# Mobile Intel® Celeron® Processor on .13 Micron Process in Micro-FCPGA Package

Specification Update

*December 2004*

Document Number: 251309-025

**Figure 12. System Bus Reset and Configuration Timings**

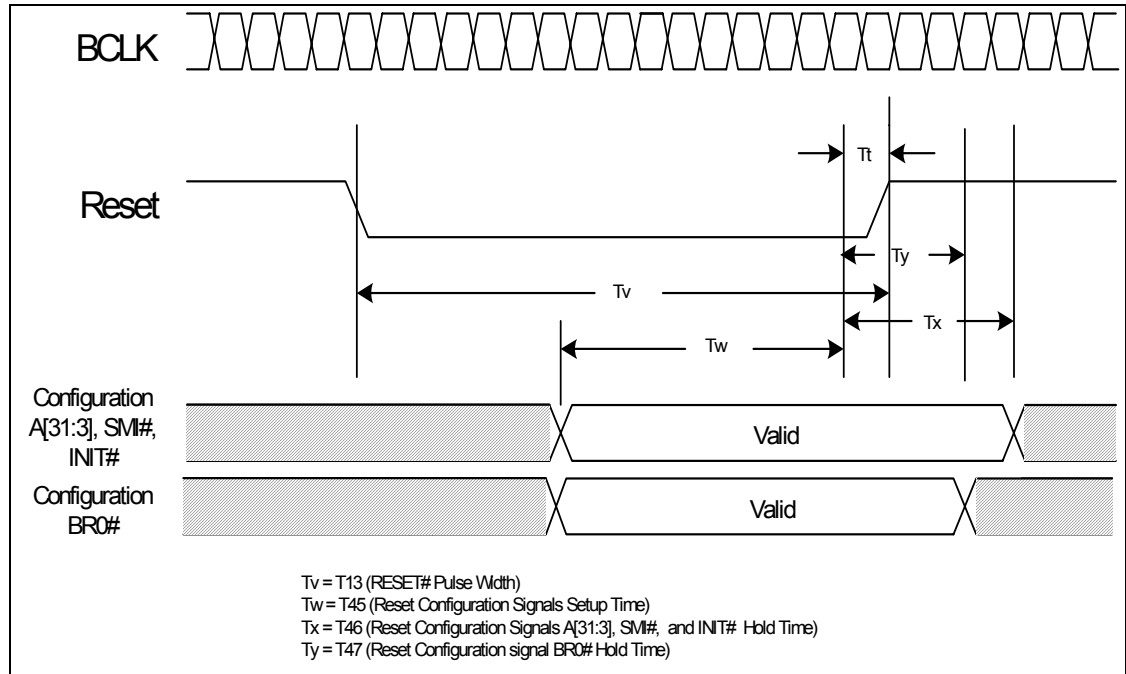
## V2. BR0# Maximum Hold Time Specification Change

The BR0# maximum hold time has changed to 2 BCLKs. This change will be shown in the “System Bus AC Specifications (Reset Conditions)” table and “System Bus Reset and Configuration Timings” figure of the *Mobile Intel® Celeron® Processor on .13 Micron Process in Micro-FCPGA Package Datasheet*. This change will be incorporated in the next revision of the datasheet.

The following figure will be modified to reflect this change:

T# Parameter	Min	Max	Unit	Figure	Notes
T45: Reset Configuration Signals (A[31:3]#, BR0# INIT#, SMI#) Setup Time	4		BCLKs	13	1
T46: Reset Configuration Signals (A[31:3]#, INIT#, SMI#) Hold Time	2	20	BCLKs	13	2
T47: Reset Configuration Signal BR0# Hold Time	2	2	BCLKs	13	2

1. Before the deassertion of RESET#.
2. After clock that deasserts RESET#.
